E-19 Ira Lee Siphon Project  
Solicitation Number: CO-00250-SM  
Job No.: 19-0108

ADDENDUM 2  
12/12/18

The purpose of this Addendum is to issue a revision to the Contract Documents for E19: Ira Lee Siphon Work (SAWS Job No. 19-0108).

**LINE CLEANING & SUGGESTED BYPASS ROUTE**

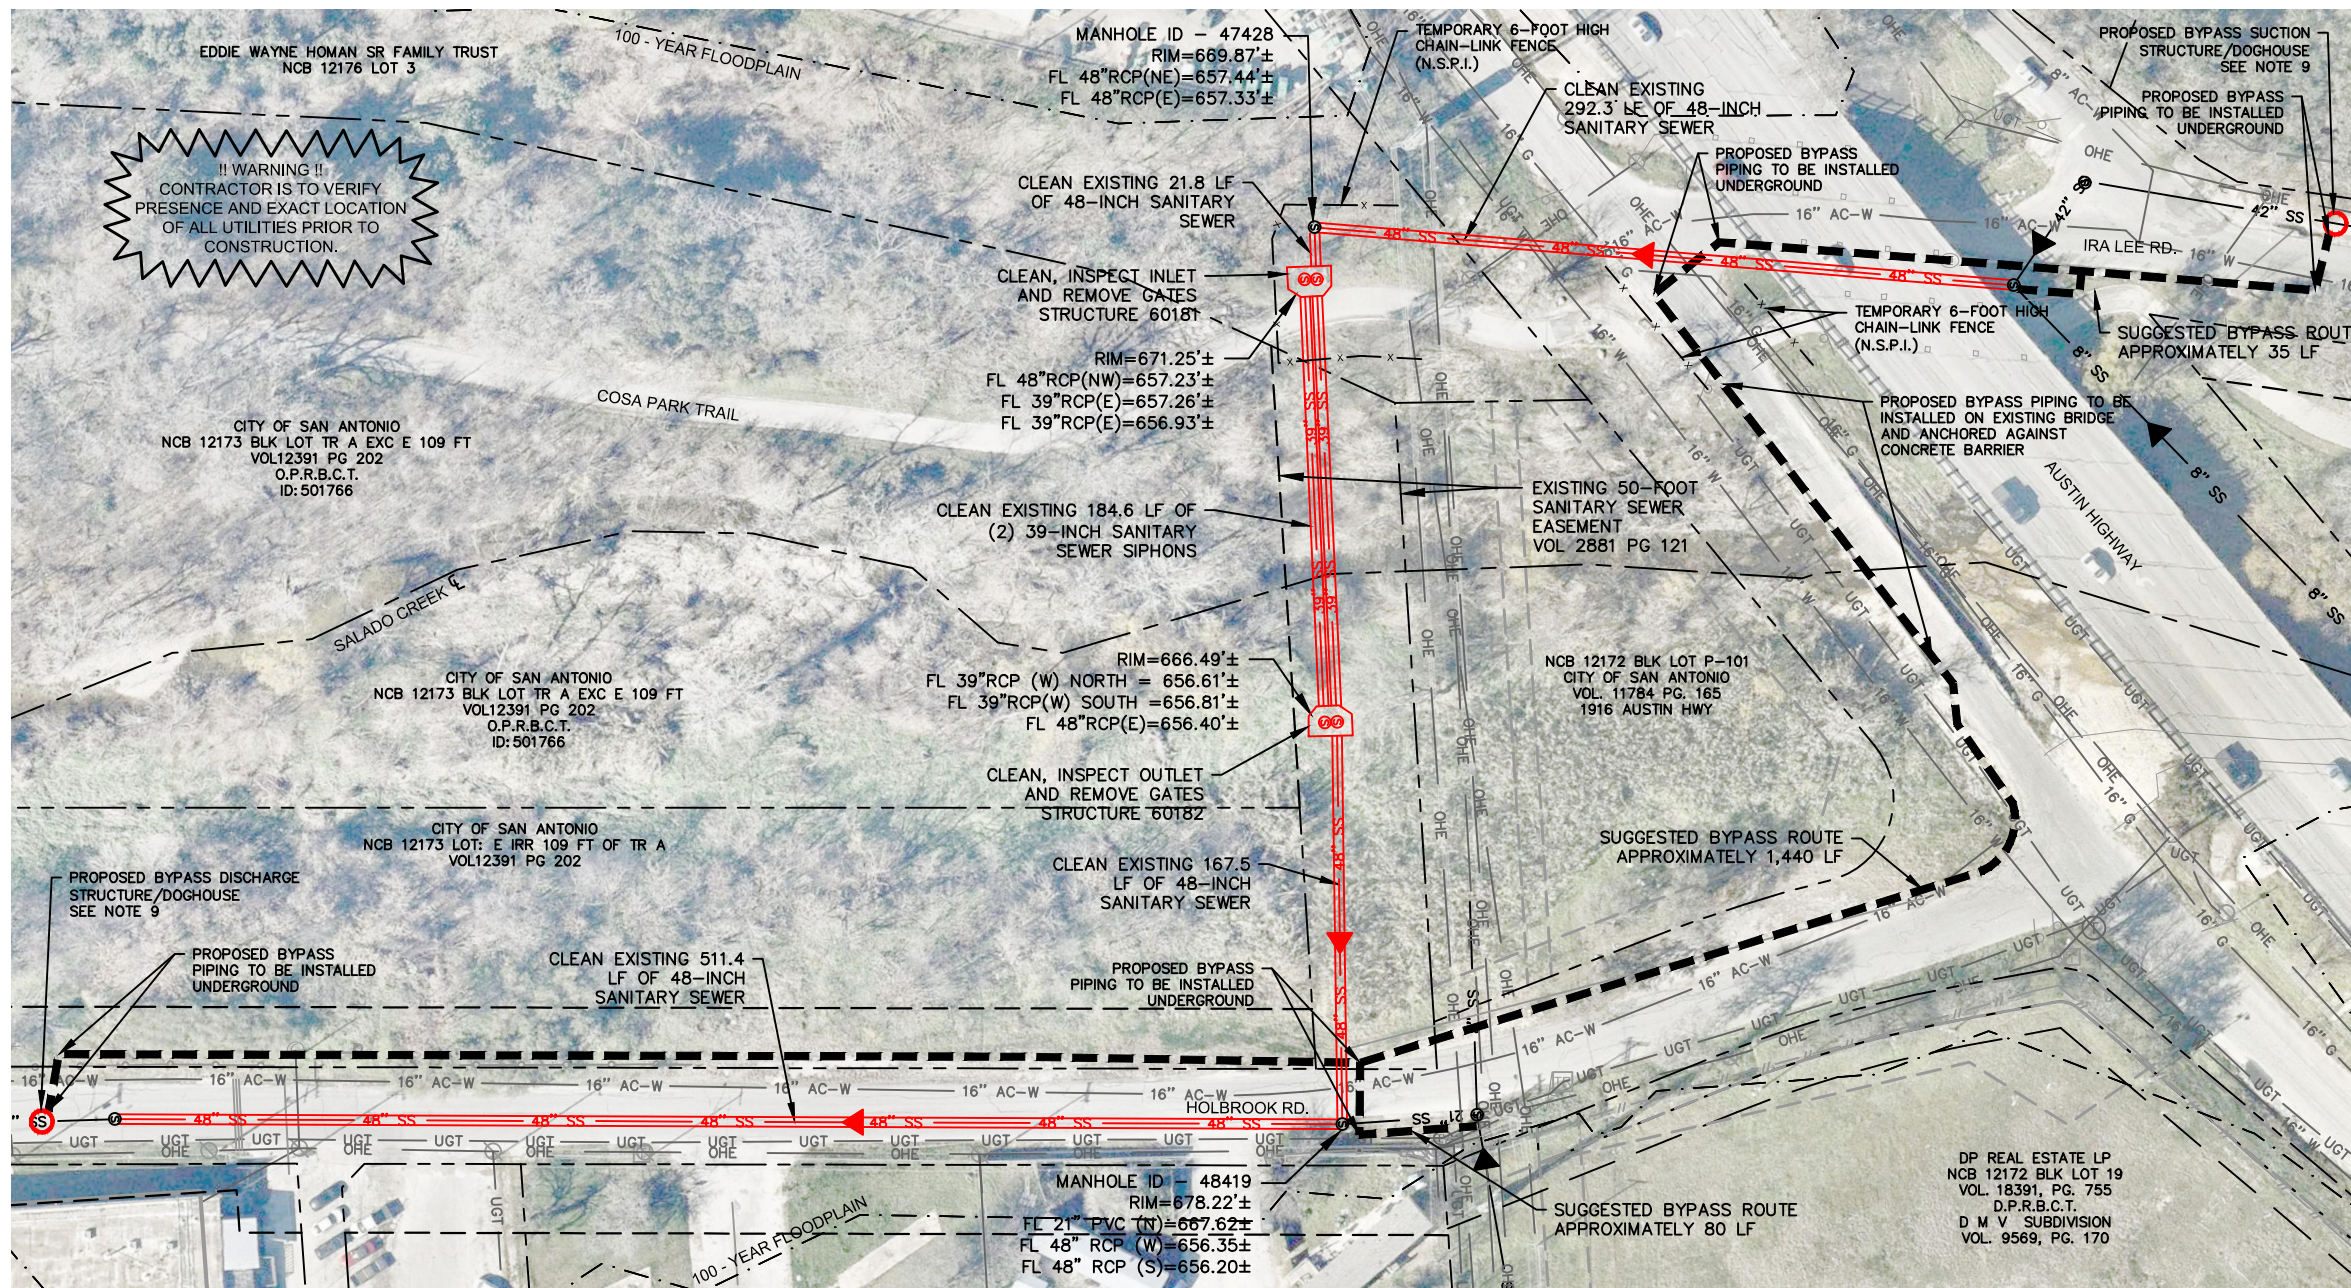
Q8: Please verify that the sewer bypass system will only be required to pump the peak dry weather flow of 28.7 MGD and that the contingency plan for flows exceeding this is to release the sewer plugs.

1. Delete Sheet C1 Line Cleaning & Suggested Bypass Route in its entirety and replace with attached Sheet C1 Line Cleaning & Suggested Bypass Route provided in this Addendum.

*The bypass system shall have a capacity of pumping peak wet weather as shown on the Contract Documents. This part of the system is surcharged on a regular basis, so it is likely that the Contractor will have to bypass flows ranging between peak dry weather and peak wet weather flows shown in the Contract Documents. See revised Contract Documents.*

FLOW TABLE			
MANHOLE ID	AVG. DRY WEATHER FLOW (MGD)	PEAK DRY WEATHER FLOW (MGD)	PEAK WET WEATHER FLOW (MGD)
47428	22.3	28.7	37.2
48419	0.8	1.2	4.8
